Why is the development team resubmitting the overall SDD?

Special Development District (SDD) Summary: September 13, 2016

Special Development District (SDD)
 Summary: November 21, 2016 Resubmittal

SDD Amendment Modifications

Why is SD2 being broken into three different parcels, and only the garage being submitted today?

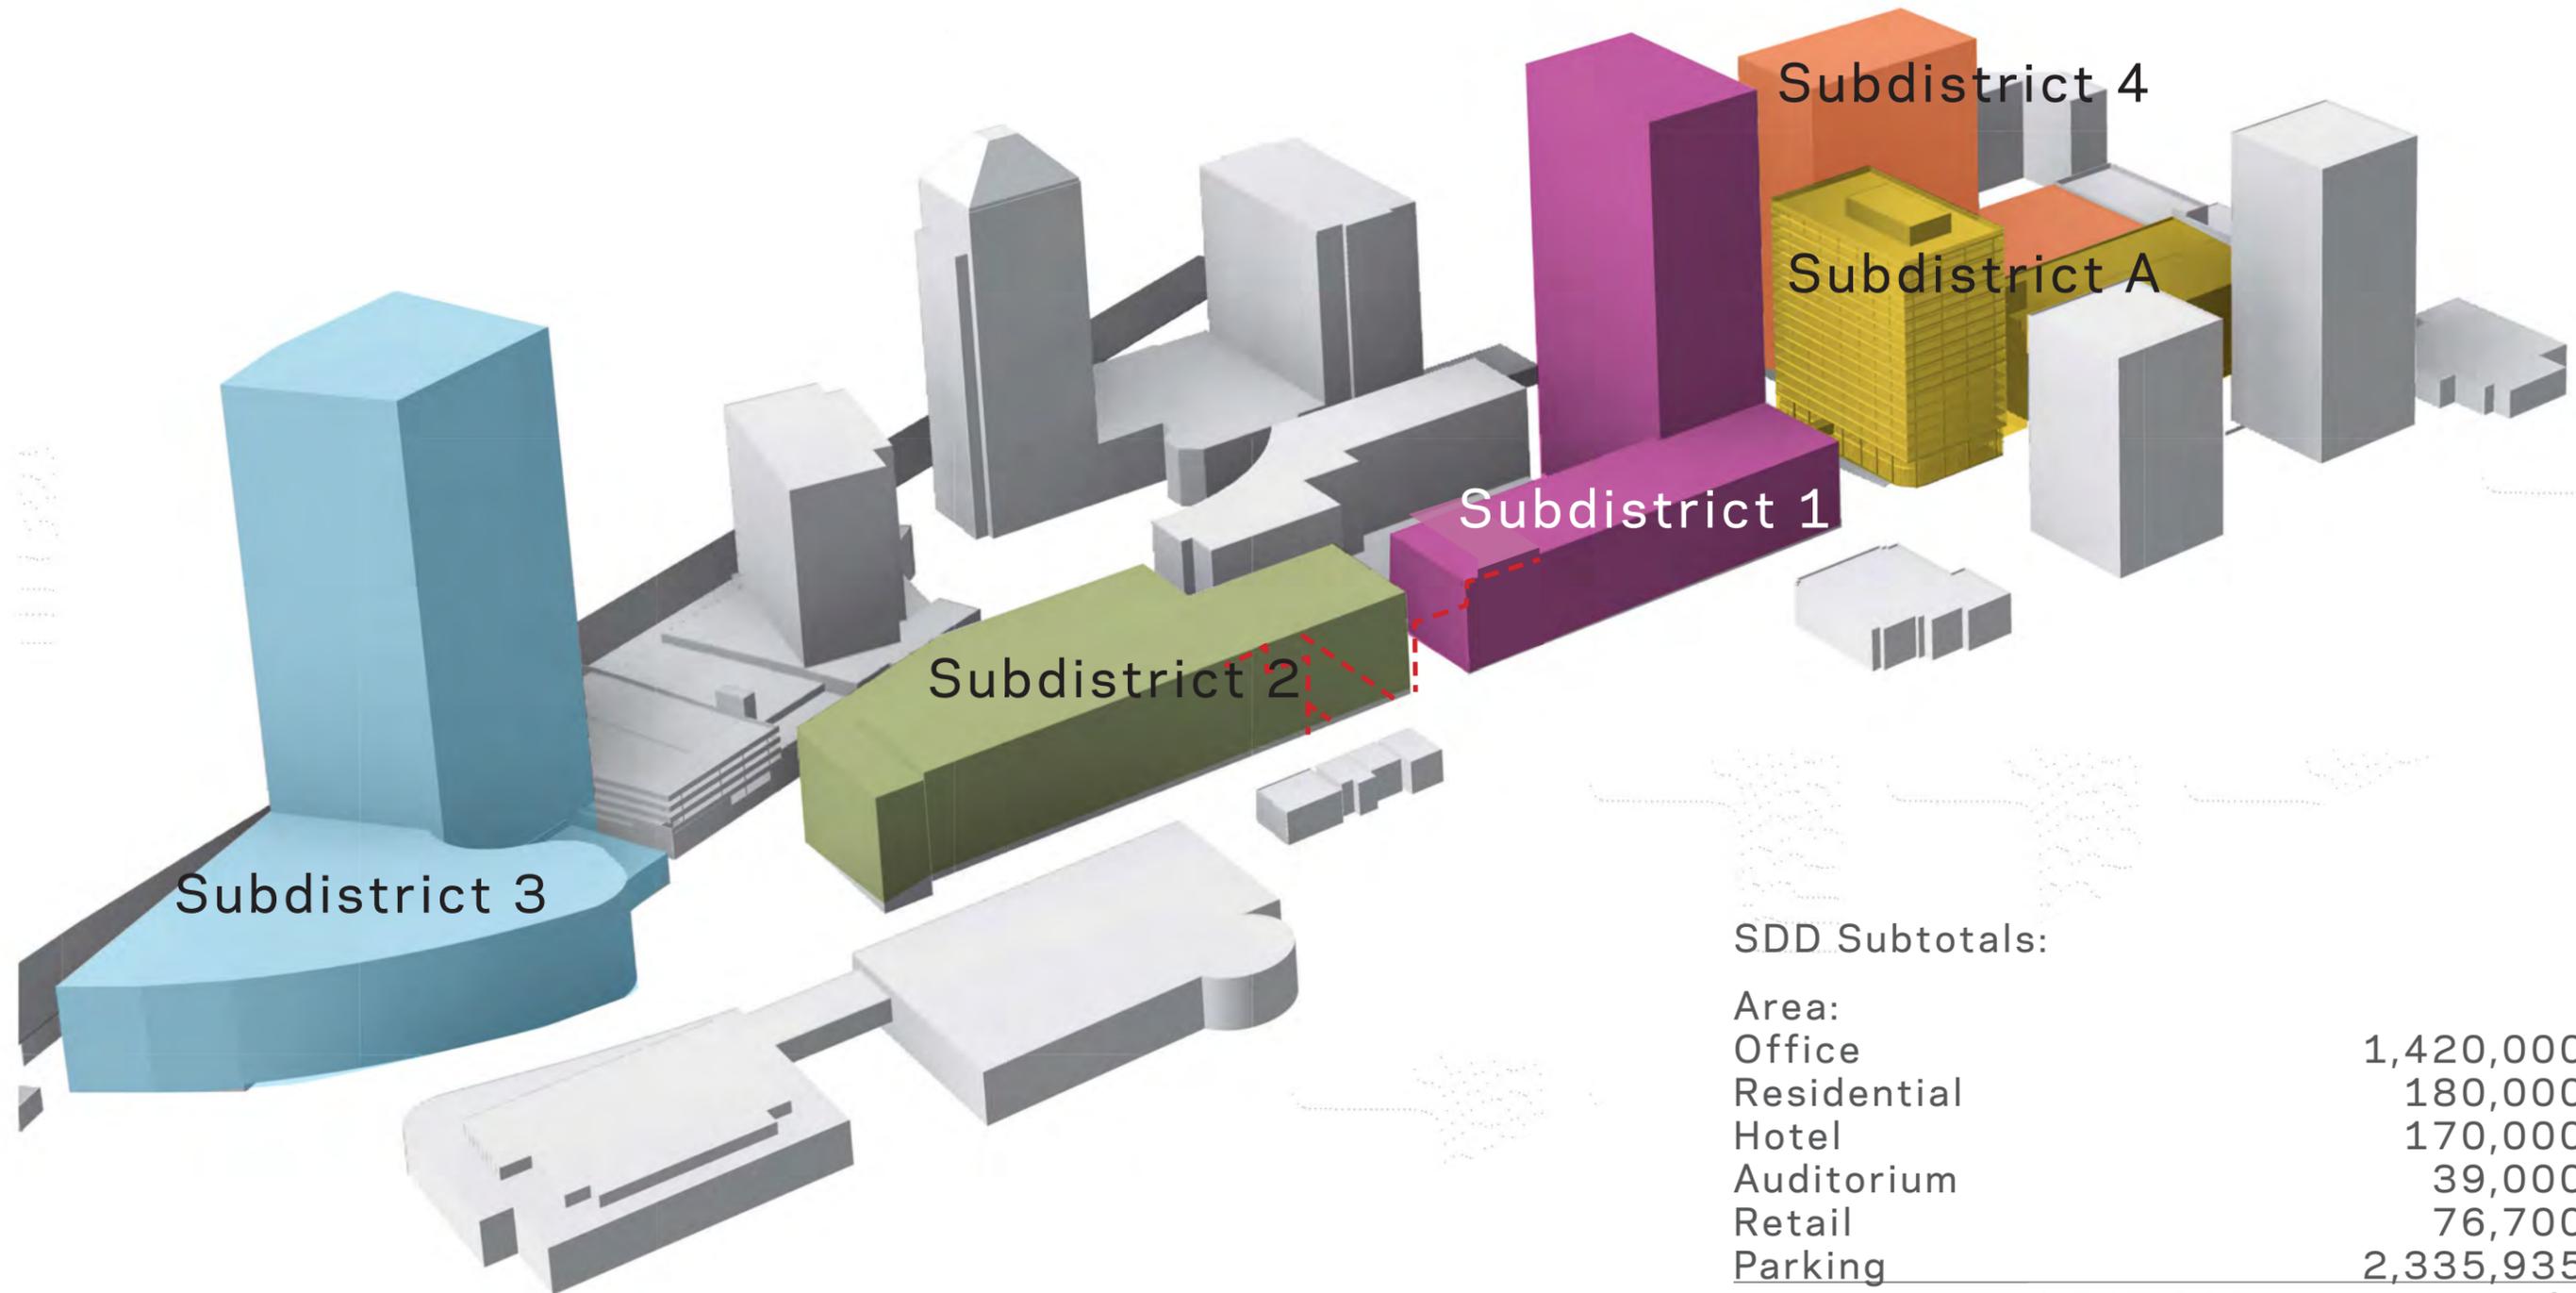
Response: In order to facilitate the construction of a new, three-story facility for Wellbridge and street-facing retail at the corner of Forsyth and Hanley, new parking must be accommodated quickly on SD2. This will allow for concurrent construction of the SD1 tower and parking on 2A, with the SD1 garage phased after Wellbridge is relocated to the new facility.

Phase 2B will construct the new Corporate+Civic Auditorium.

Phase 2C will construct a new residential development.

Given their complexity of design, 2B and 2C will have longer timeframes to develop and seek approvals than the planning of the 2A garage.

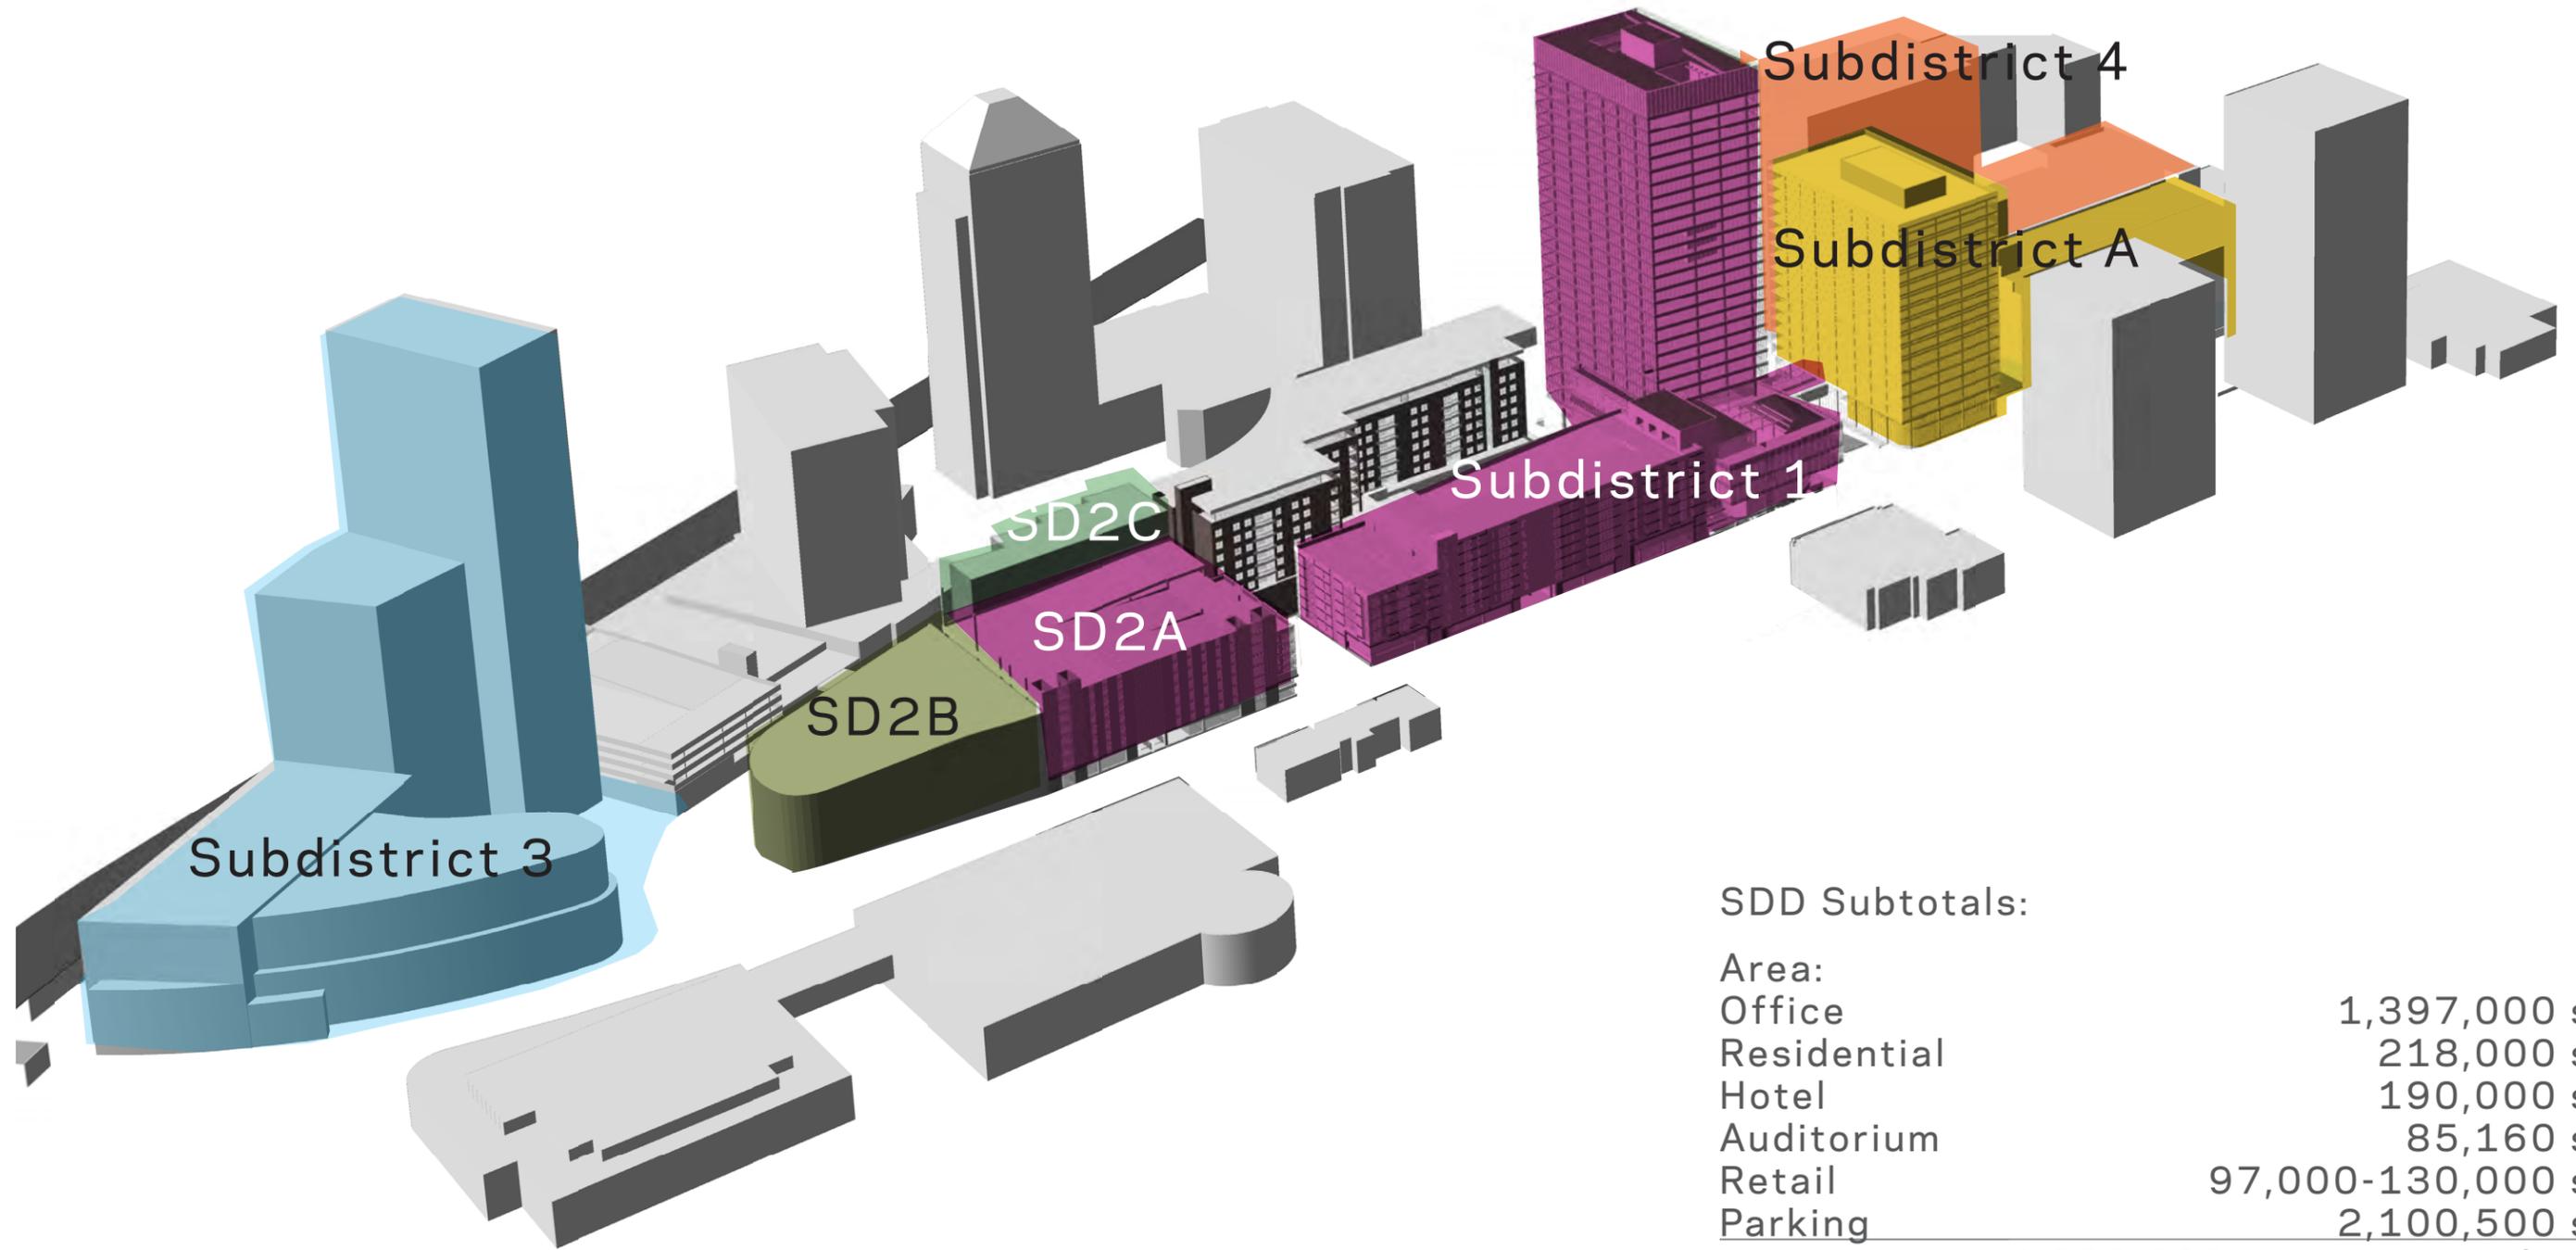
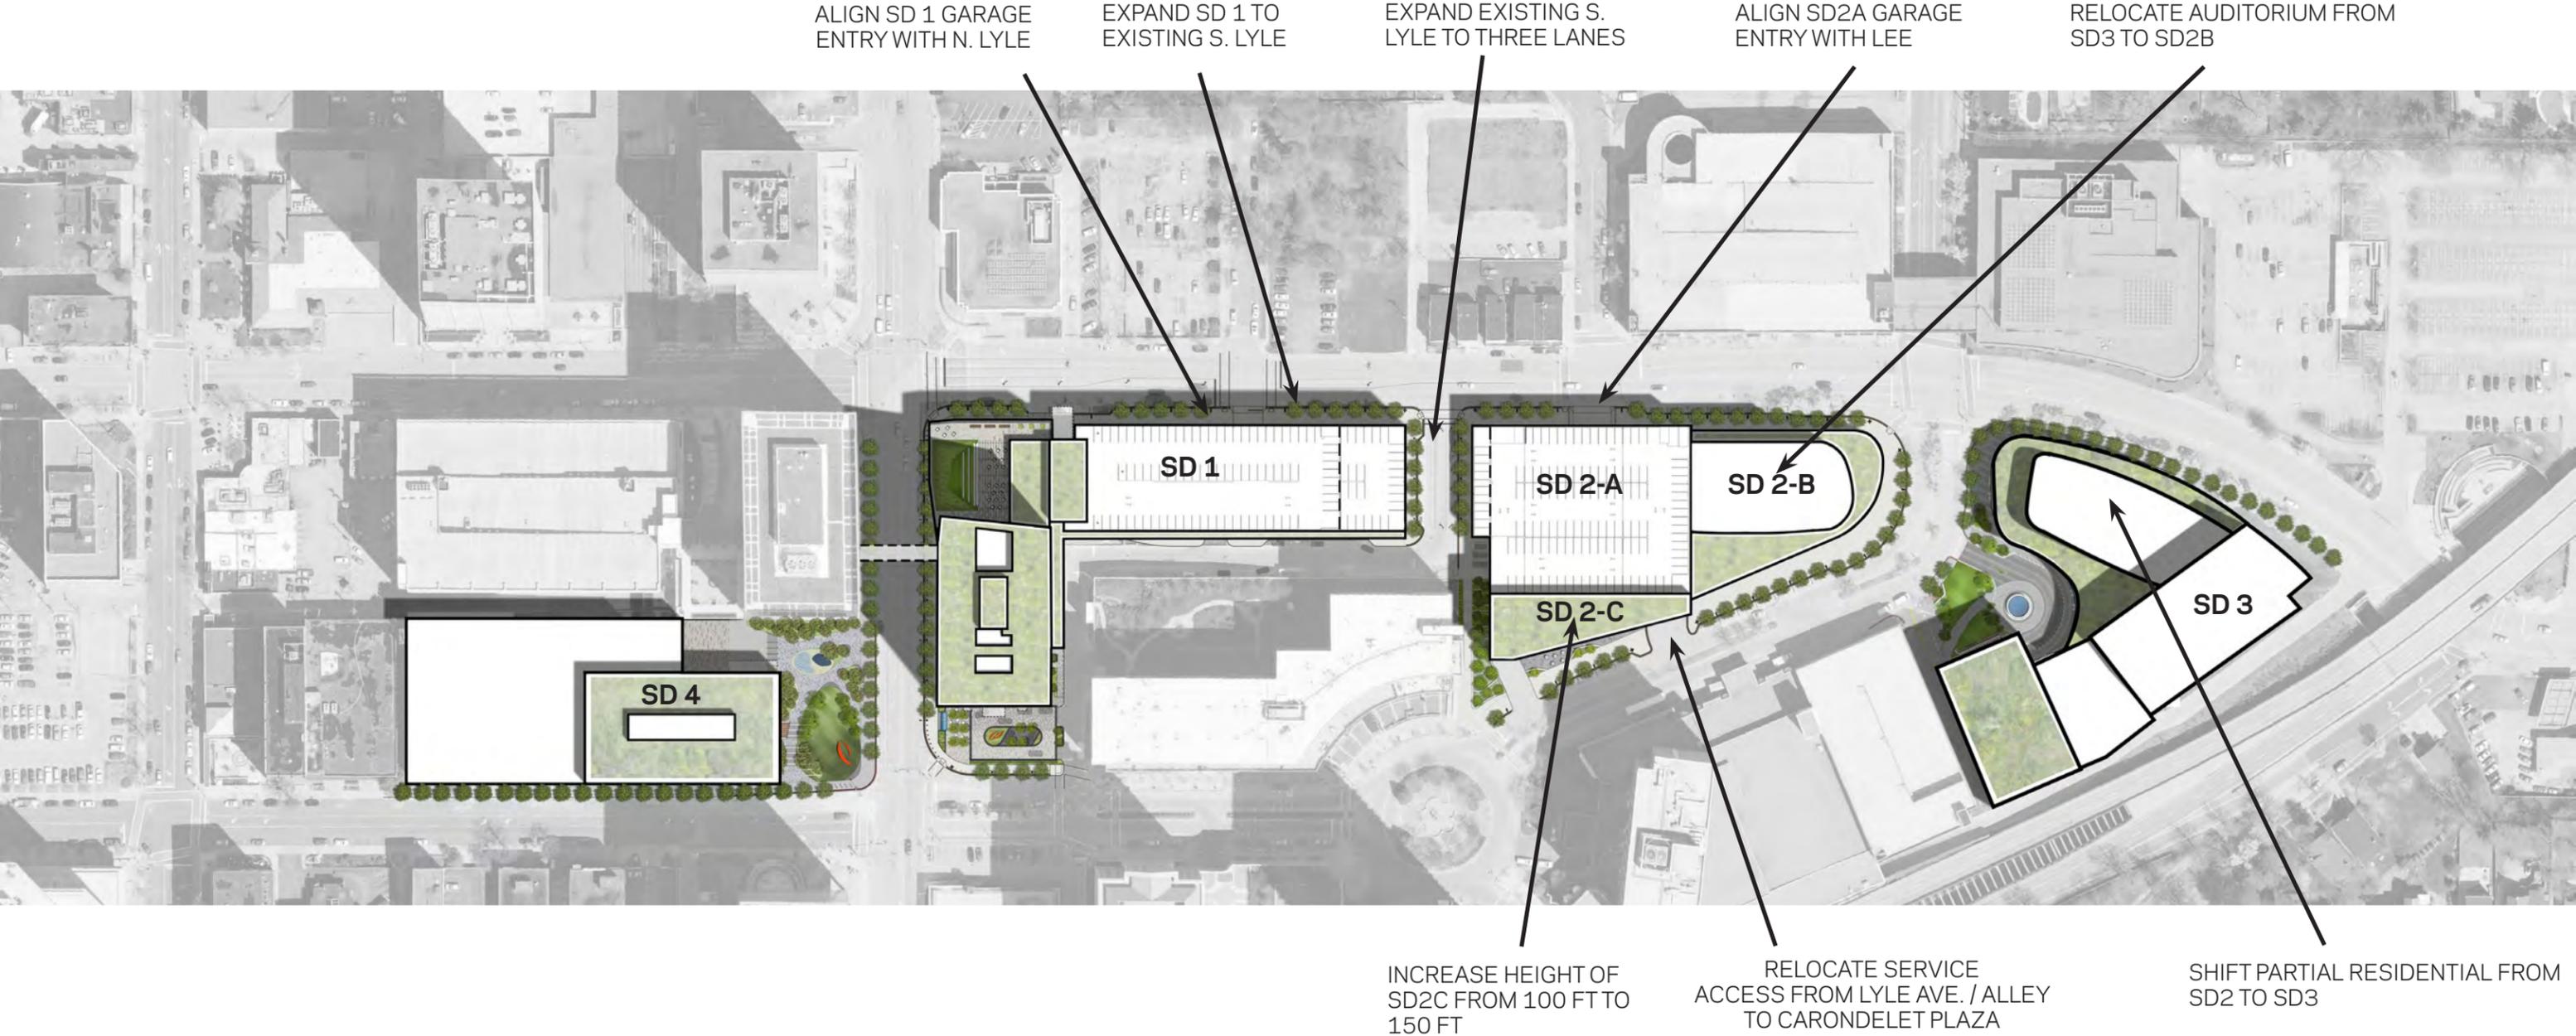
Response: **No**. The overall construction area that Centene is requesting in this updated SDD has, in fact, been reduced slightly from 4.58M square feet to 4.32M square feet. A few key details:

1. The majority of the reduced area can be attributed to **a removal of approximately 235,000 sf of structured parking** from the project, in alignment with the approved maximum 5,800 parking spaces.

2. Total **office space remains essentially the same**, with only a 1.6% reduction from September's approval to the current, more detailed design - 1.397M square feet in our current SDD versus 1.420M square feet in September's approval.

3. The balance of **housing, retail, retail-ready, and corporate lodging space remained essentially the same**, with a only a 5.3% increase in area as the design has progressed. This added area is approximately the same square footage that was reduced from the office area.

4. **The overall tower heights and heights along Forsyth are unchanged** between our current SDD and September's approval. We are asking for an additional 50' of height for the residences on SD2 to accommodate the reduced site area that resulted from the city's requests for traffic and connections.
